NEW VALVES ON LPG CYLINDERS

WHAT HAS CHANGED?

Image 2

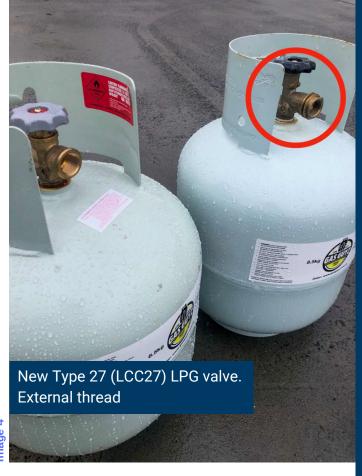
- 1. The LCC27 will have an external thread on the fitting (**refer to image 2**). This new thread will be used for new appliances with the LCC27 connection in the future, and has a right-hand thread.

New Type 27 (LCC27) LPG valve. Phasing in from 1 April 2021
